KN PLANNING PTY LIMITED

Ref:KN693/02

**Re: State Significant Development Application-82900461 for demolition of four (4) dwellings and erection of 9-storey residential flat building and associated basement parking
11-19 Middle Harbour Road Lindfield
Submission of objection on behalf of 9 Middle Harbour Road Lindfield**

Drawing DA203 Section E-W showing setbacks from No.21

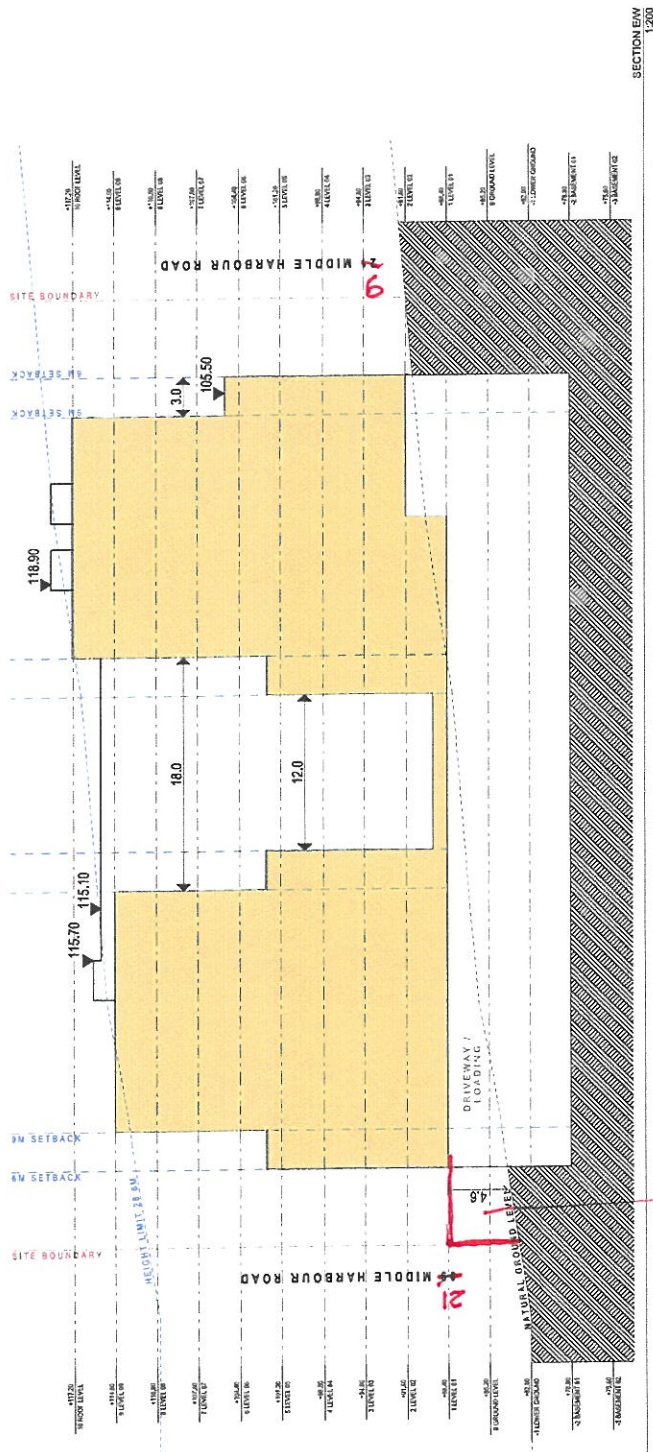
The proposal will present as a 10-storey building for a length of 58 metres with a setback of 6-metres for 5 levels and 9 metres for the remaining levels (*Figure 16*). The properties 21 to 29 Middle Harbour Road fall within the Lindfield TOD Precinct.

Figure 17: Drawings 402/A and 403/A – Shadow impacts on adjoining properties

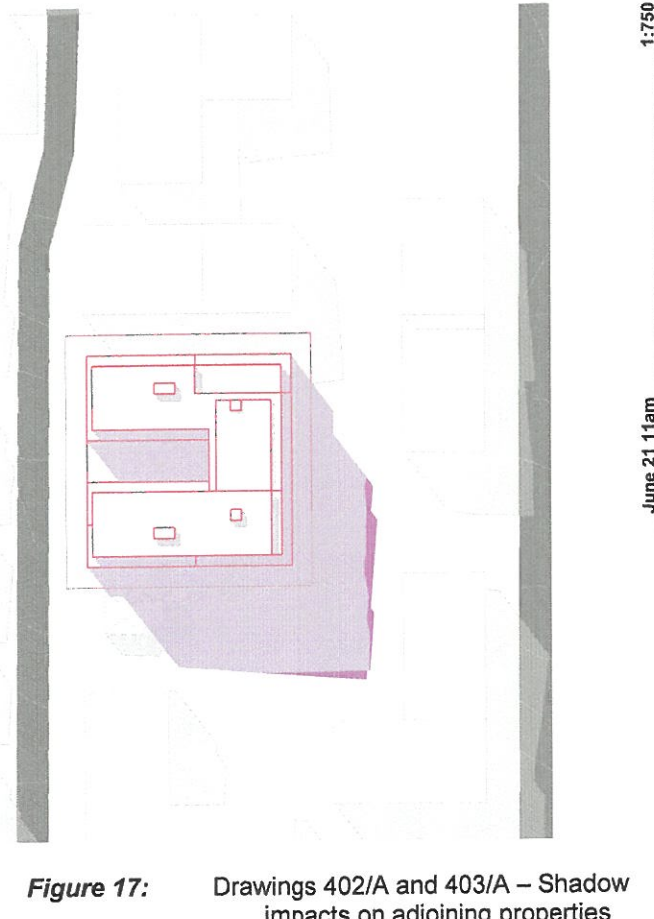
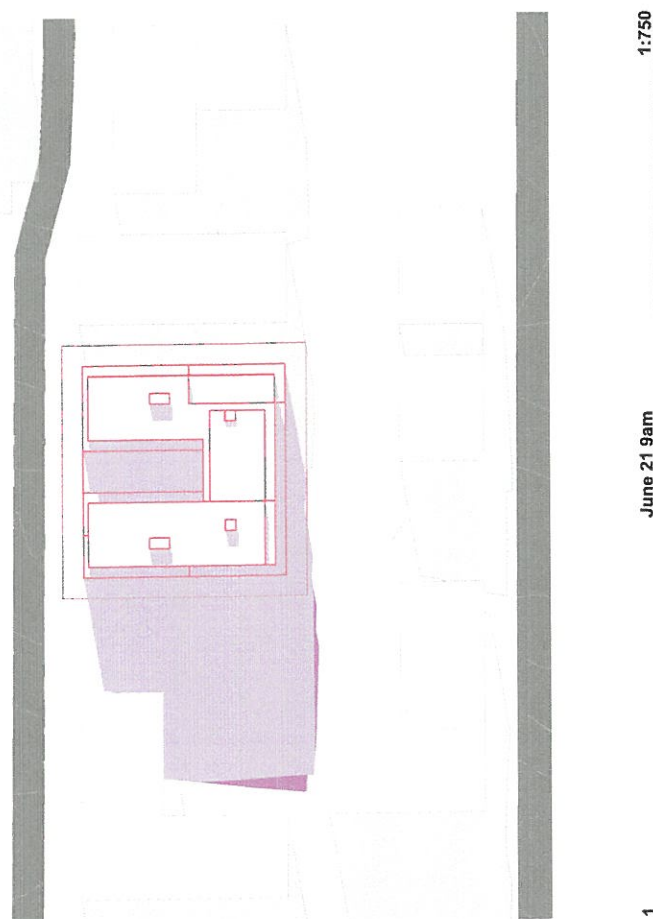
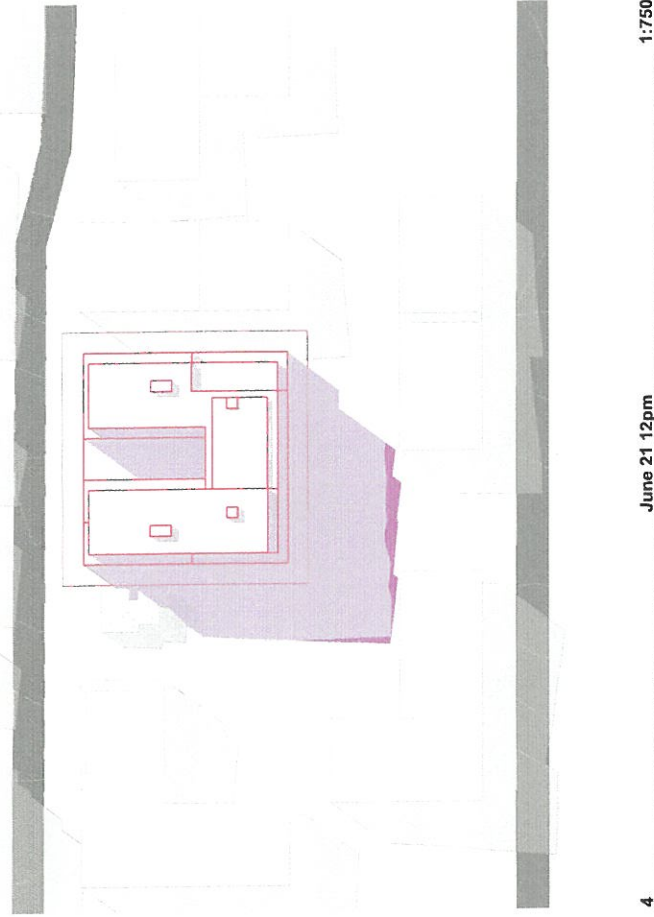
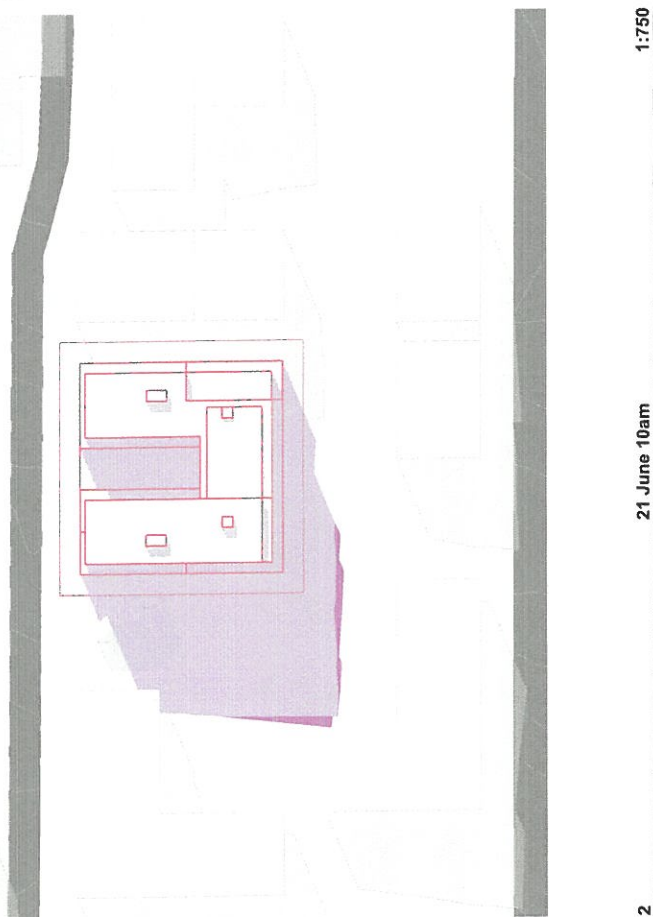
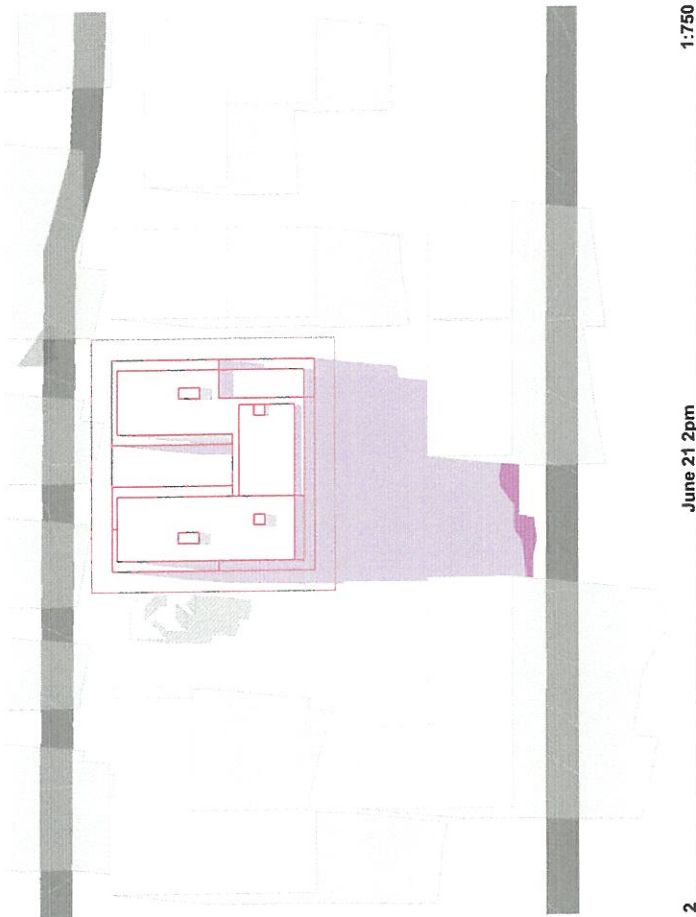
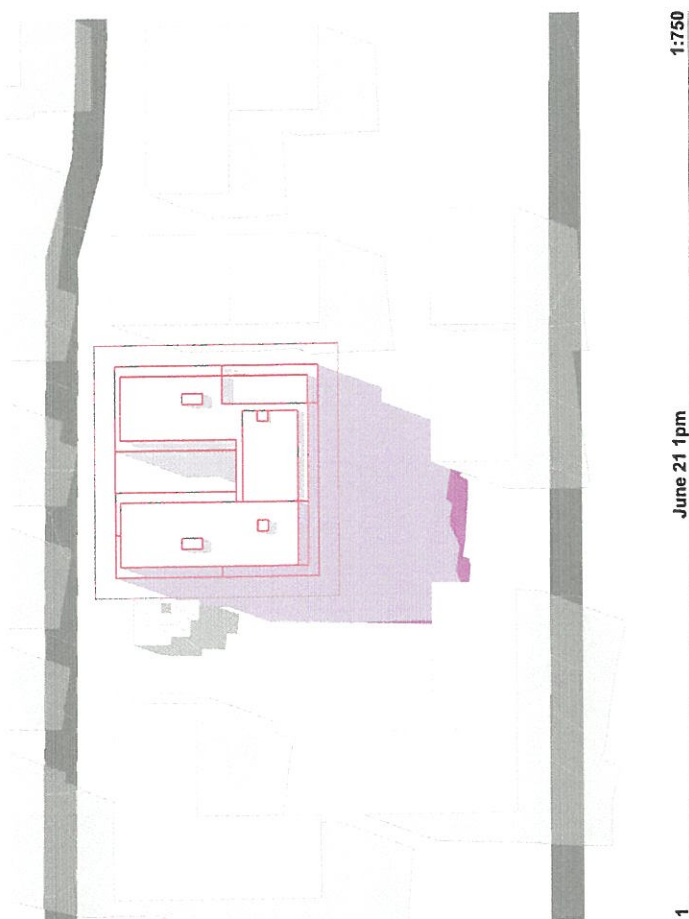
The proposed increased height over the bonus height provisions in clause 16(3) will increase the extent of overshadowing on properties to the west, south and east of the development site adversely impacting on the amenity and liveability of existing and future residents.

The visual dominance of the proposed structure is clearly evident when the overshadowing impacts on the adjoining properties are assessed, as indicated at *Figure 17*. The principal internal and external living areas for the residence at No. 9 are orientated towards the eastern boundary of the site. The effect of the proposed development is that the principal living areas for No.9 will not receive direct sunlight in mid-winter between 9am and 3pm. The existing swimming pool south of the outdoor private open space will also be similarly impacted by overshadowing arising from the proposed development.

The extent of overshadowing impacts on the future TOD sites in Chelmsford Avenue will be significant particularly given the limited depth of the allotments compared to the Middle Harbour Road lots thus restricting solar access to any north facing future apartments setback 6 metres from the rear boundary of the subject site.

Figure 18: Landscape Concept report - Deep Soil

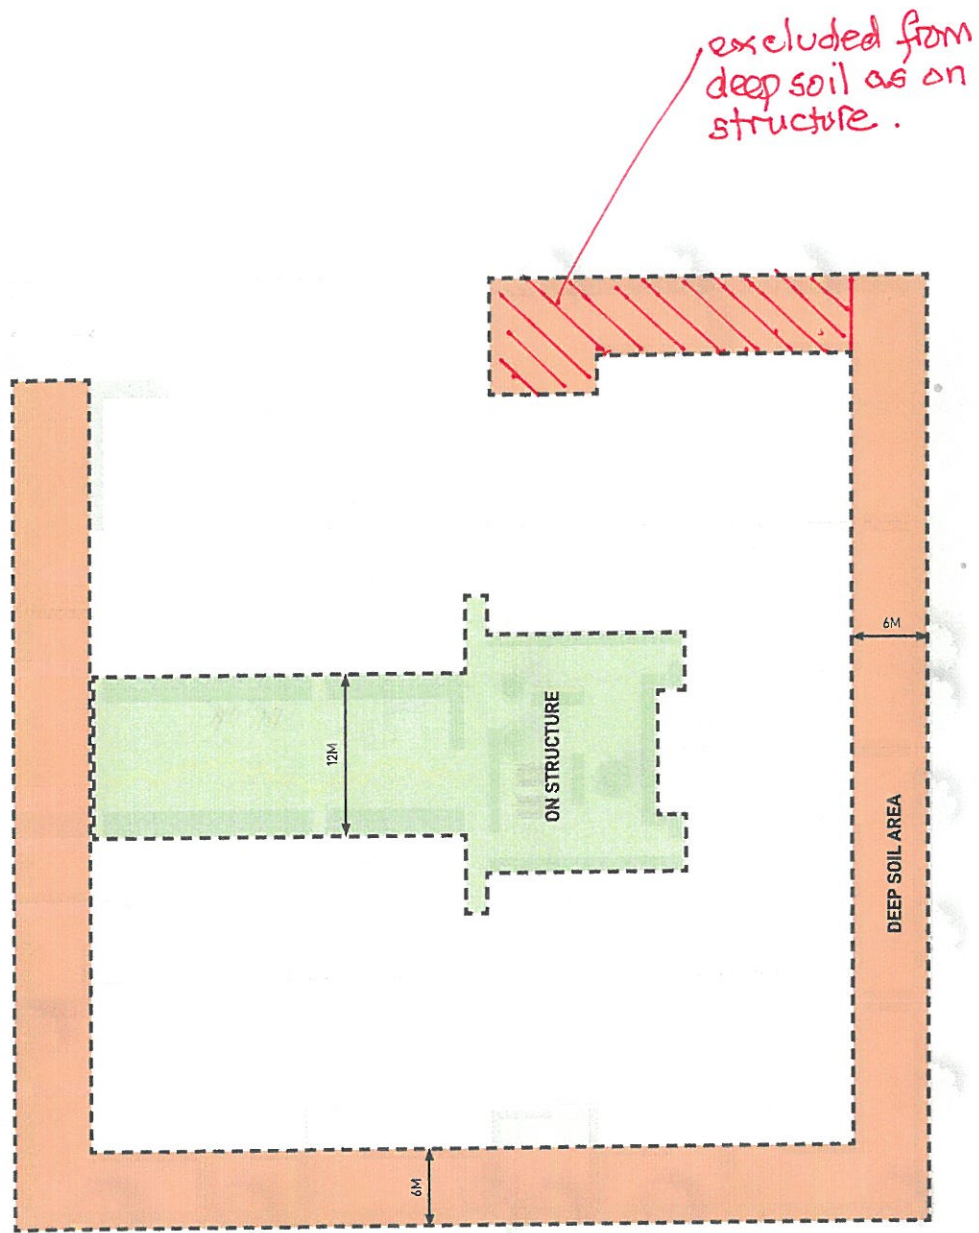
The Landscape Concept Report prepared by Ground Ink embodies a plan showing deep soil landscape area (*Figure 18*). The plan includes an area on the eastern boundary that is sitting on the slab over Basement 01 car parking which represents an area of 190 square metres.

There appears to be some confusion between various documents as to the extent of deep soil planting with reference to 1379m² in the EIS and 1070m² in the Design Report and Architectural drawings (Drawing DA504). The correct figure appears to be 1070m².
